3-2 – 12

Proposed Change as Submitted

Committee Review of Comments and Action – July 2013

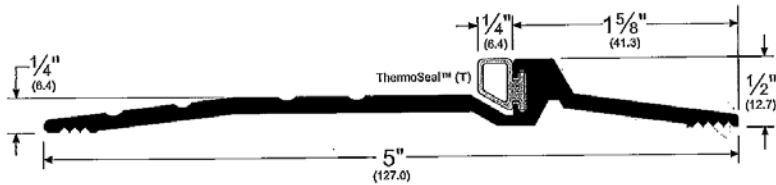
ICC – Kim Paarlberg**Negative Ballot**

Comment/reason: I agree with BHMA-Michael Tierney and NACS- Brad Gaskins. The bump at the top of the threshold is often part of weather seals on doors and has not been shown to be a problem for accessibility. See attached example.

Figure 4 - Turning diameter (examples for various wheelchair types)

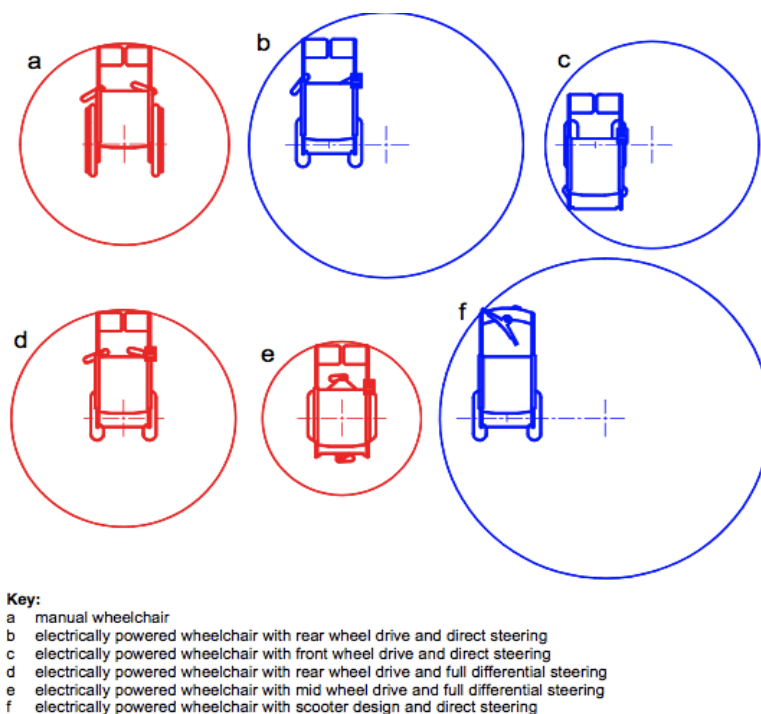
The IDeA team provided very helpful diagrams illustrating the 5 different 180 turns used by the subjects in the IDeA report. The Spot and Pivot turning techniques appear to need a width just a few inches greater than the diagonal of the user's wmd. The Shuffle turn uses whatever space is available though repeated short back and forth shuffles while turning around incrementally. The Three Point turn is a T turn with upraised arms. It was the Full U turn where both wheels move forward but the outside wheel moves faster that required the most width. The Pivot and Three Point turns use a 'corner'. The subjects were allowed to choose their preferred method for turning, but the IDeA report does not identify who used which technique, so a question exists as to who needs the extra space to successfully turn or to avoid excessive energy expenditure and who could function with less space than they used.

Further, we were informed that the best shape for a 180 turning space is a lozengen. The IDeA team recommended that the long dimension be 88 inches and the short dimension be 68 inches. Because the shape only works if a user enters the space

This observation raises the question – should the built environment be changed to accommodate poorly designed wmds or ought those choosing poorly designed wmds be informed that their vehicle may not be well accommodated? The analogy is the parking lot at the grocery store. If you choose to drive a stretch limo, RV, bus, or other vehicle that is bigger than a typical parking space you are welcome to shop, but don't expect a parking space near the entry. Ultimately this is a political and not a technical question.

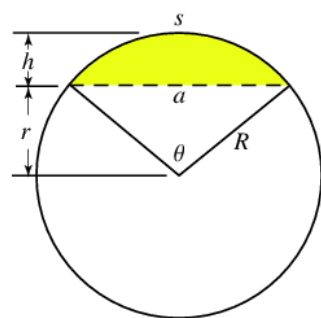
Comment: The committee disapproved this proposal because it was concerned that the proposed language was unclear and because they were not convinced that the turning circle would be usable with this change. Because we believe that the proponent was correct to want to limit the amount of space that elements can intrude into a turning space, even those with knee and toe space beneath, we propose two options for amending this proposal. Option #1 would allow on obstruction approximately 8.8" deep ($30 - (30 / 1.4142) = 8.8$) or, for a circle with a 67" diameter 9.9". Because a 90° arc will form an equilateral triangle, we divide the radius by the square root of 2, we get a segment of a 30" or 33 ½" long radius. That sum subtracted from the radius is the depth of the circle between the chord and the perimeter of the circle. Option #2 would simply not allow intrusions into the turning space.

304.3.1 Circular Space. The turning space shall be a an unobstructed circular space with a 60-inch (1525 mm) minimum diameter. ~~The turning space shall be permitted to include knee and toe clearance complying with Section 306.~~

Figure 304.3.1

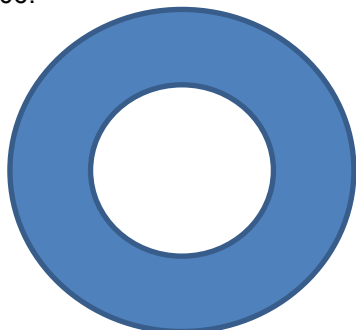
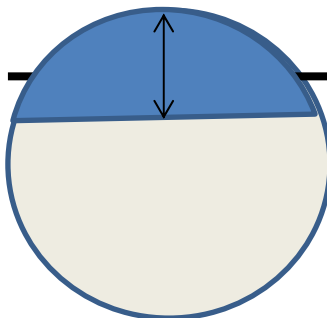
Reason: See the graphic in the ballot statement. The current circle language would allow a 'doughnut' effect. This language would allow for the current 25" maximum knee and toe clearance under a straight counter along a turning space. If the committee desires less of an overlap, the length of the cord and the depth of the sagittal could be revised accordingly.

Committee Reason: The debated the geometry of intrusions allowed in the turning circle based on the current text. As there is no limit on the intrusion, the standard technically allows intrusions for the full circle which results in the donut shape seen below. The committee felt that the concept of the original proposal of limiting intrusions to a portion of the circle was appropriate, but struggled to find text and

figure which would be clear to users of the standard. The committee accepted the modified text and figure 304.3.1 as the best expression of the intrusion limit they find appropriate.

While I agree that the permitted overlap should be addressed, I do not agree with the final modification to limit the overlap to 10" maximum. This is inconsistent with the T-turn allowance of 25 inches maximum overlap. The data from Dr. Steinfeld provided for a greater depth of 16" where knee and toe clearance were provided. If we want to make a change to the allowed depth, we should have justification and be consistent.

304.3.1 Circular Space. The turning space shall be a circular space with a 60-inch (1525 mm) minimum diameter. The turning space shall be permitted to include knee and toe clearance complying with Section 306. Where the turning space includes knee and toe clearances under an obstruction, the overlap shall comply with all of the following:

1. The depth of the overlap shall not be more than 10 inches, and
2. The depth shall not exceed the depth of the knee and toe clearances provided, and
3. The overlap shall be permitted only within the turning circle area shown shaded in Figure 304.3.1.

Proposal 3-9

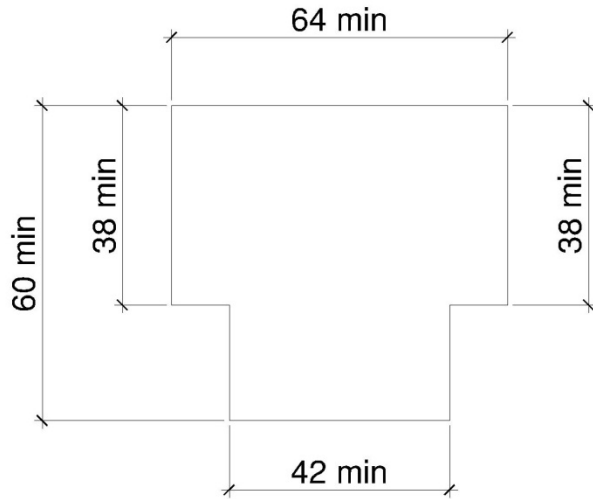
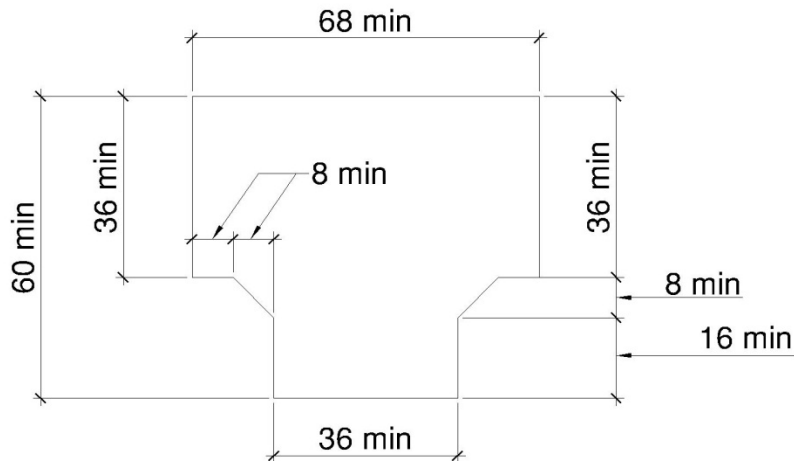
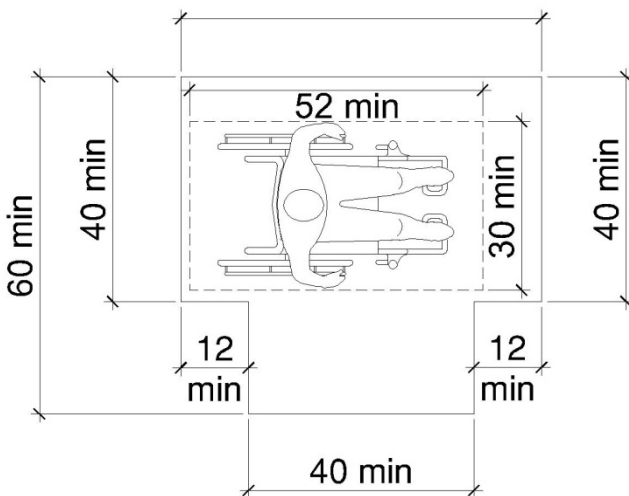
Reason: The Wheeled Mobility Task Group (WMTG) was created as a task group of the A117.1 Committee to analyze the results of the anthropometric study of a variety of mobility device users conducted by The Center for Inclusive Design and Environmental Access (IDeA) at the University at Buffalo, SUNY recently completed an anthropometric study of 500 wheeled manual and powered mobility device users. The study indicates that the technical provisions contained in the A117.1 standard do not address the needs of the full range of users of mobility devices. The work of the WMTG is ongoing, but it has submitted a series of proposed changes to the base building blocks of the A117.1 standard. If the changes to the building blocks are adopted by the Committee, then additional changes will need to be made in other portions of the standard.

Comment: The "base" entry should be shown in the diagrams as the intended entry point is not clear from the code language (nor can I think of a clearer way of stating the requirement!)

Comment: According to the Committee reason, text must be prepared. Although the illustration is provided, without text, it is not possible for me to vote in favor of something I have not reviewed.

Comment: We studied the impact of the required entry at the base on a series of apartment plans. We find that the requirement of entering at the base will add up to 12" to the depth of a typical apartment, but, if we allow entry from any arm it has little impact. Logically, there should be no difference where the entry to the T shaped area should be. I propose a modification of the original proposal to strike the language regarding entering and exiting through the base. Further, the entry and exit through the base restriction would be practically impossible, as there are many circumstances that would have multiple entry points, such as at a T-intersection of two hallways.

Modification *The diagrams were prepared and accepted, the text was not prepared.*

Committee Reason: The Committee explored the various options and limitations for regarding making the T-shaped turn. While the dimensions shown in the figure labeled Proposal 3-9 were the base of the discussions, the Committee concluded that the 3 designs should be shown in the text (perhaps in a table) as 3 equal options for design the space. The Committee approved the figures; asked staff to develop text.

Committee Reason: The original action by the committee after considerable discussion during the first 2 meetings was to accept the 3 diagrams shown above as describing three acceptable alternatives to the minimum design of T-turns. The committee accepted as a modification to the approved diagrams the

Replace the original proposal as follows: The figures approved shall be included in the standard to provide interpretation of the following text. The text would replace the existing text in Section 304.3.2

308.2.1, Figure 308.2.1

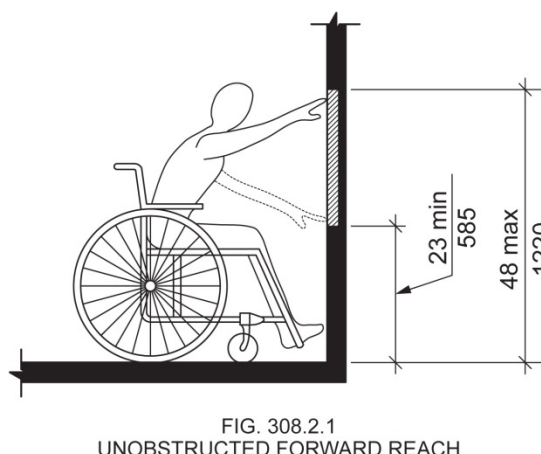
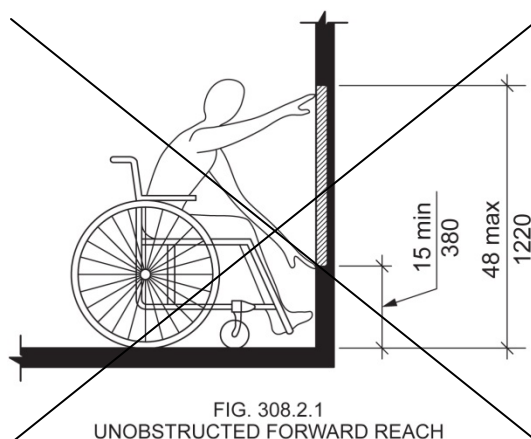
NOTE 2: This change necessitates a revision to Fig. 308.2.1 to ensure consistency. A revised figure is attached.
